LOQ-10-20.19
RECONSTRUCTION OF EXISTING SEPARATED
CROSSING WITH N.Y.C. R.R.
LORAIN COUNTY
RIDGEVILLE TOWNSHIP

TITLE SHEET	1
TYPICAL SECTION	2
CALCULATIONS-GENERAL NOTES-TABLES-GENERAL SUMMARY	3
PLAN & PROFILE	4-8
CROSS SECTIONS	9-17
BEFORE ROAD APPROACH & SIDE ROAD CULVERT	18
CULVERT & OUTLET STORM SEWERS	19
STRUCTURES OVER 20' SPAN	20-27
RAILROAD FORCE ACCOUNT WORK	28
CHANGE ORDER N° 2 (ADDED TO PLAN 12-8-52) KT	28-A, B, C.

LOR.-10-20.19
CHANGE ORDER No. 2

STA. 1079+29.96 to STA. 1081+91.04

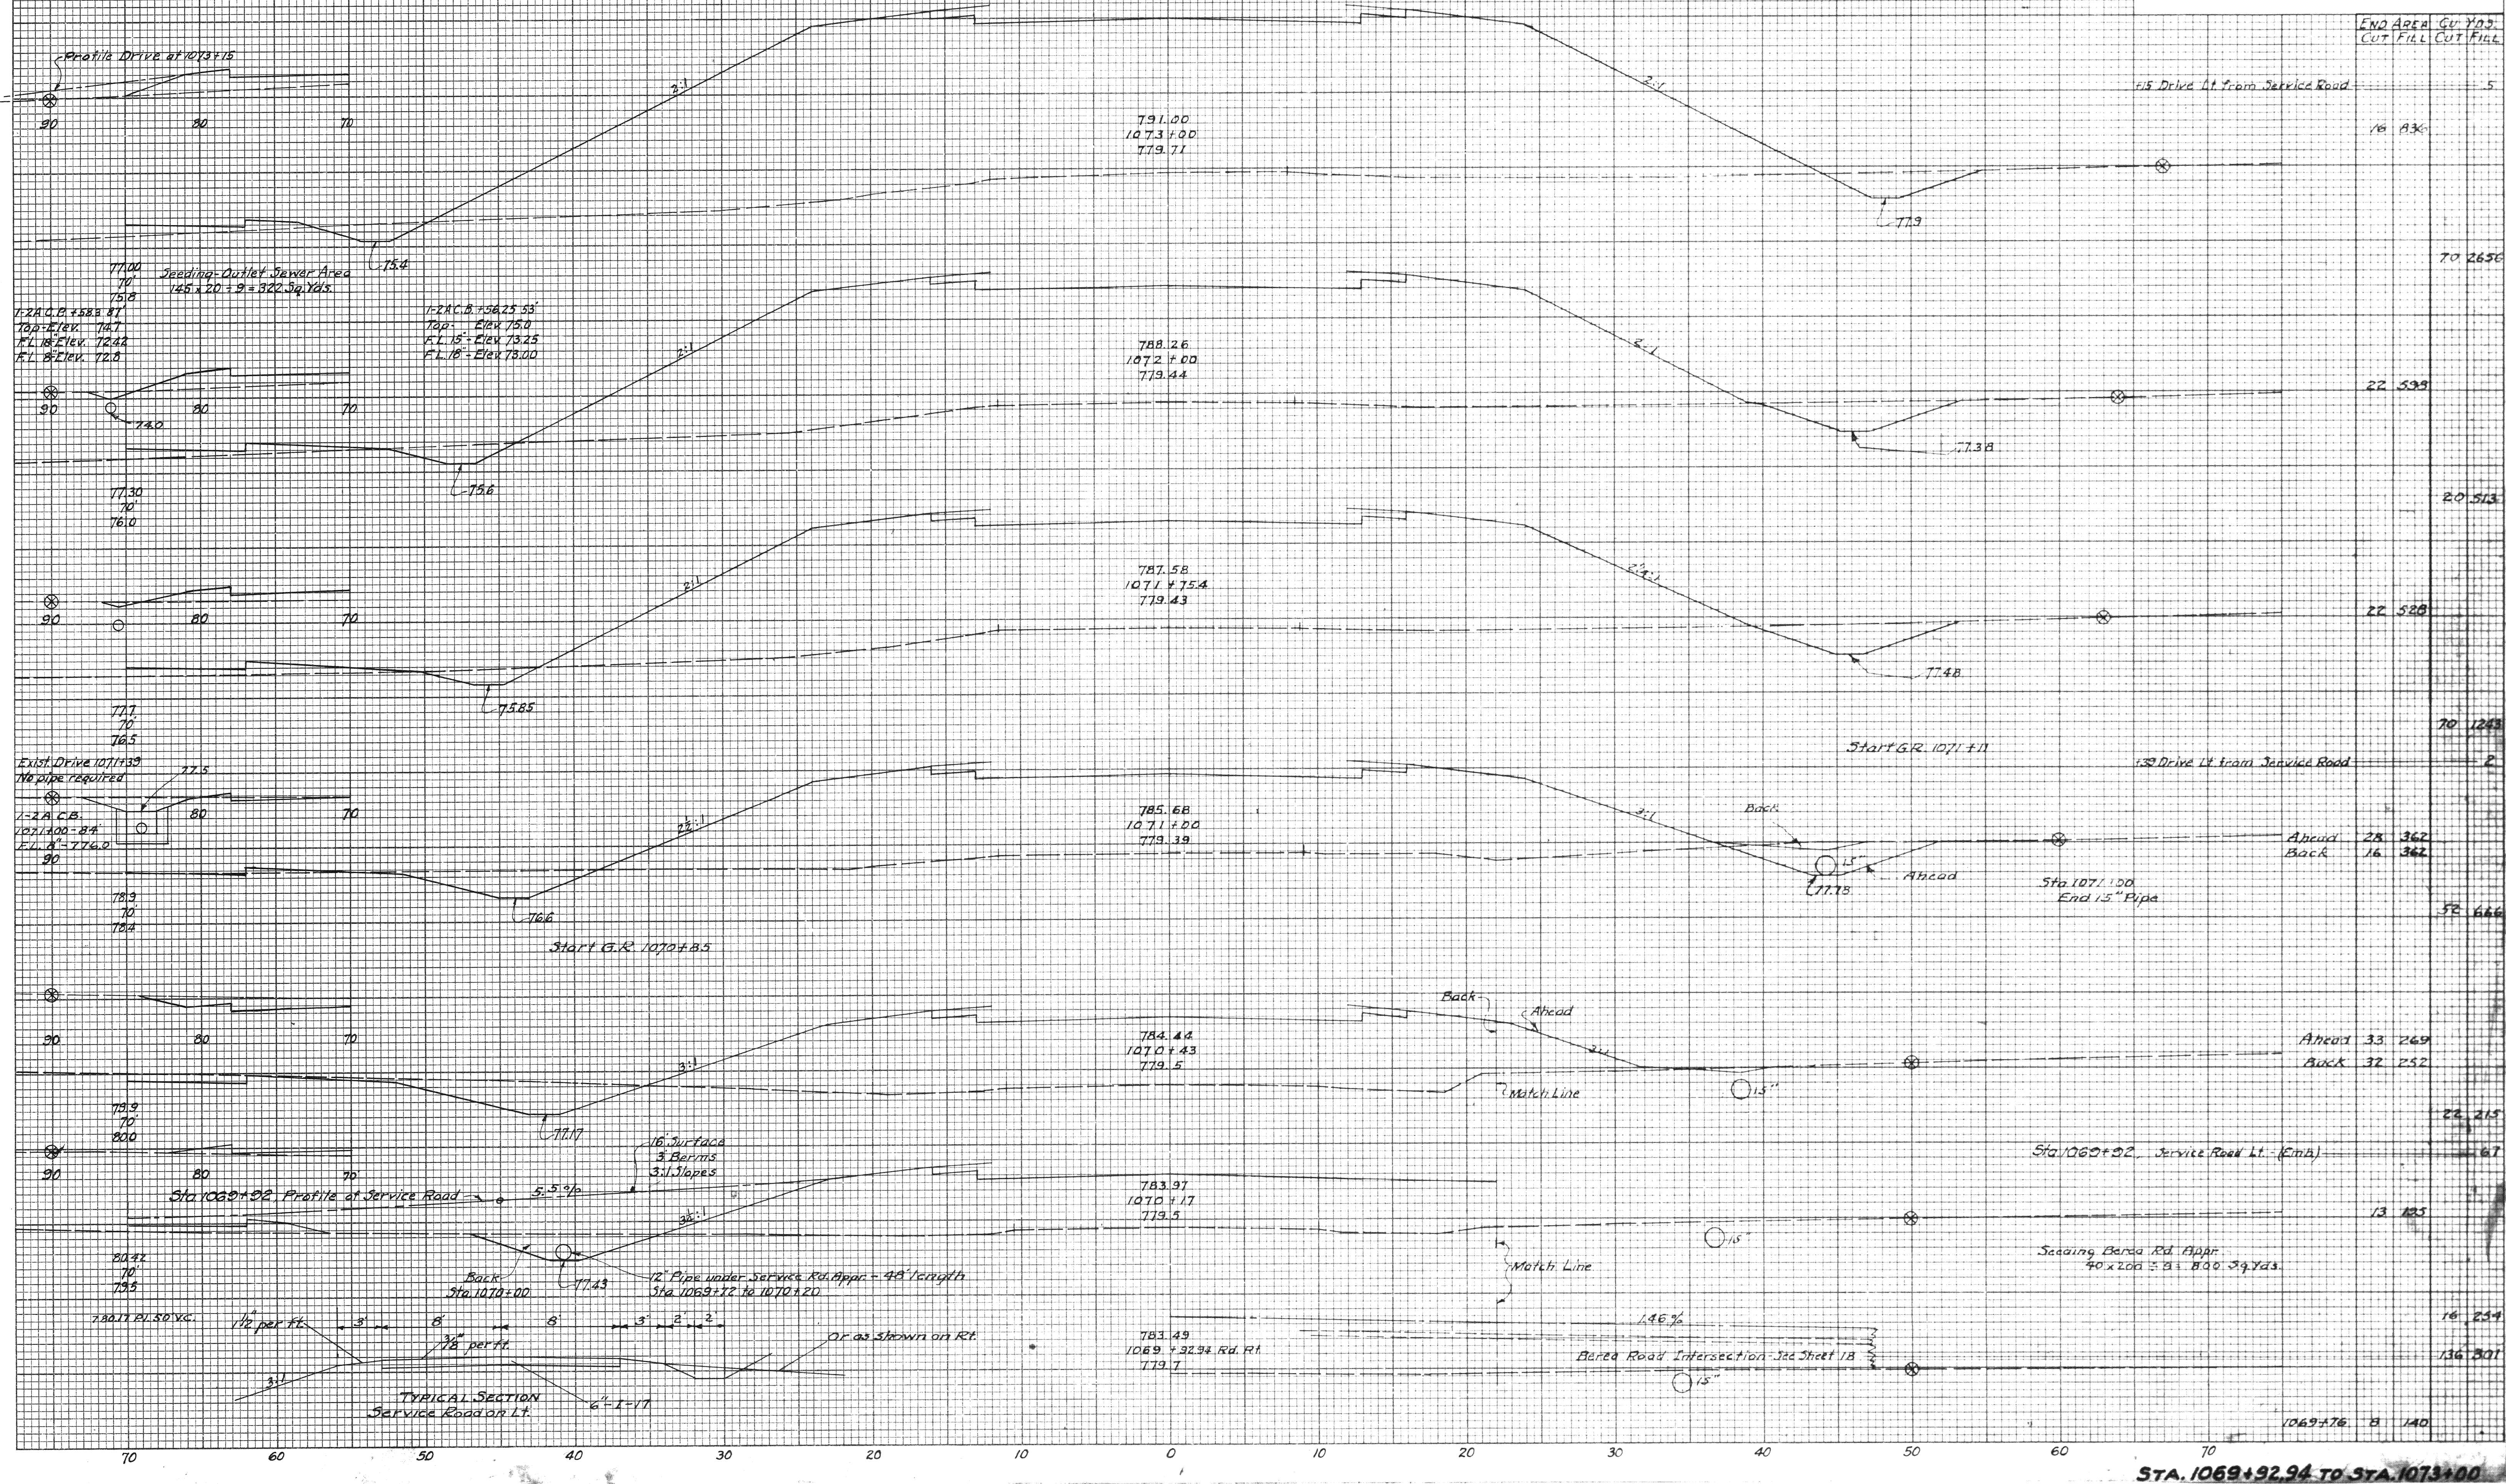
NOTE: THIS SHEET REVISED 12-20-52
SKEW ANGLE CHANGED FROM
43°30' TO 41°50'

STATE OF OHIO
 DEPARTMENT OF HIGHWAYS
 BUREAU OF BRIDGES
SITE PLAN
 BRIDGE NO. LOR-10-204
 Over New York Central R.R.
 LORAIN COUNTY
 SEC. LOR-10-20.19 STA 1080+60.5
 SCALE: 1"=20'

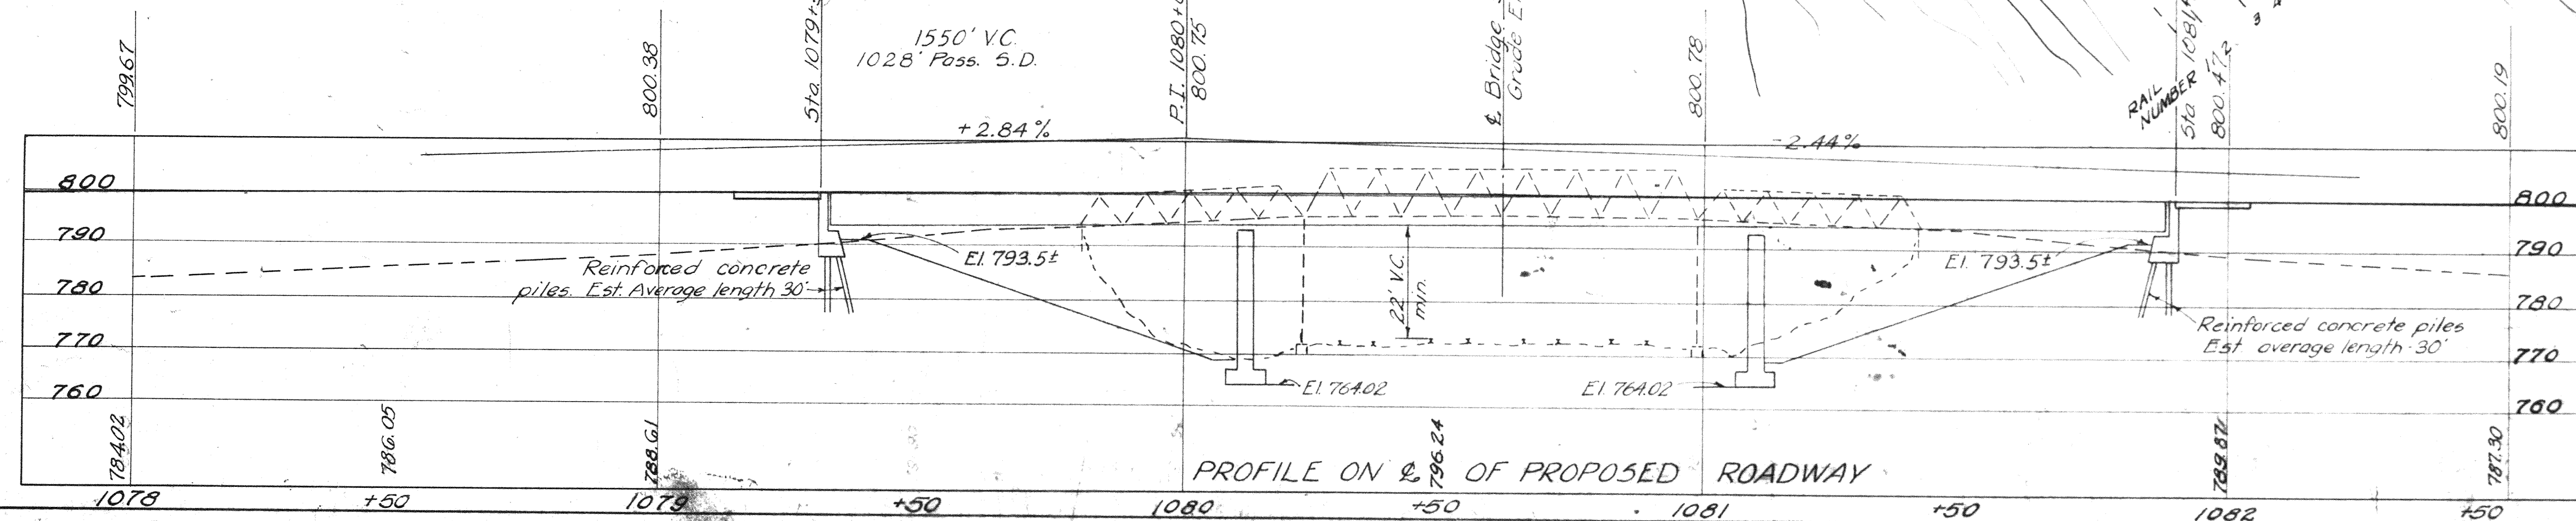
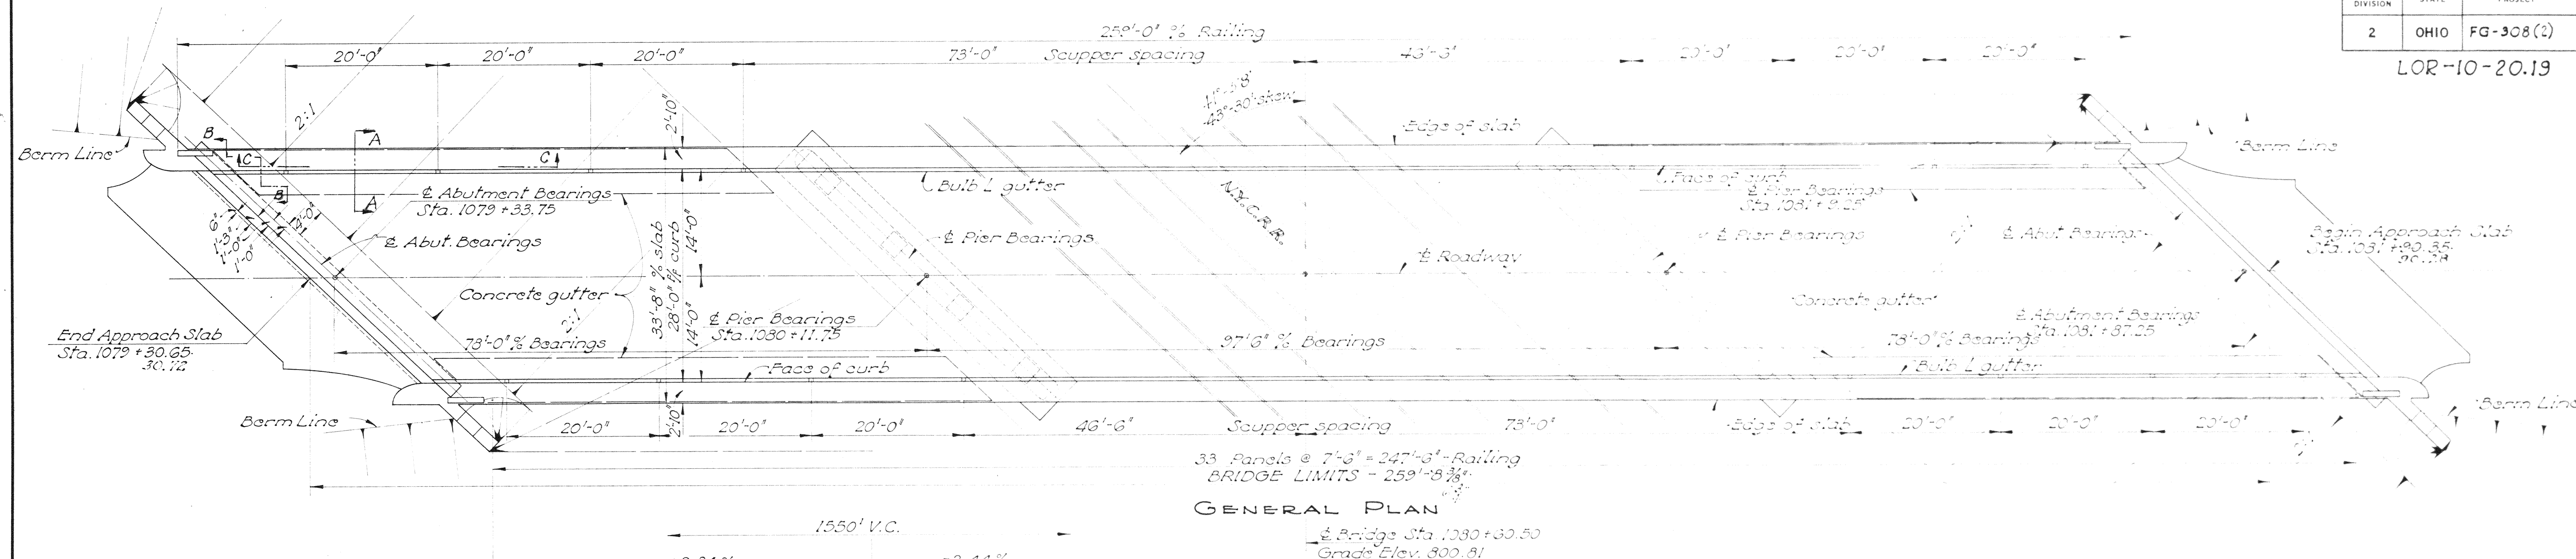
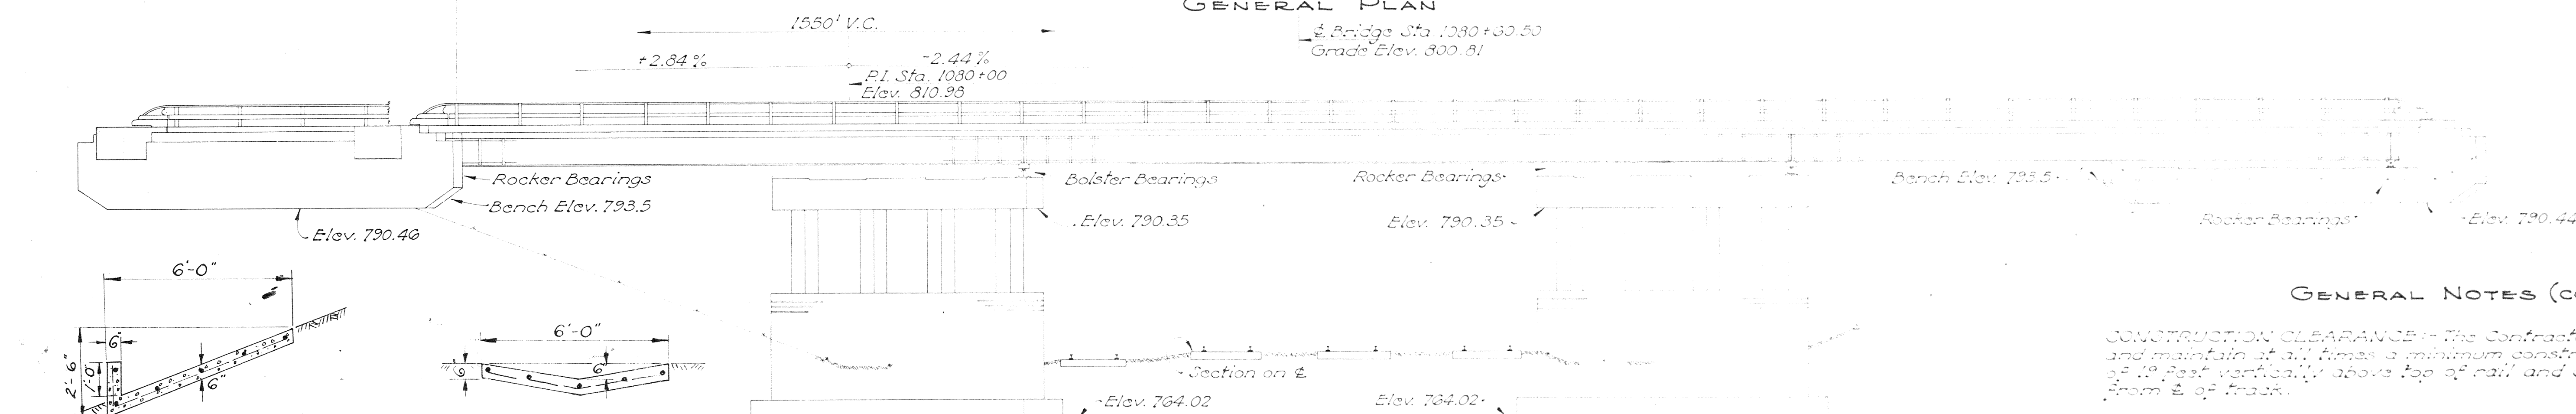
NOTE: THIS SHEET REVISED 8-25-52
 SKEW ANGLE CHANGED FROM 43°-30' TO 41°-58'
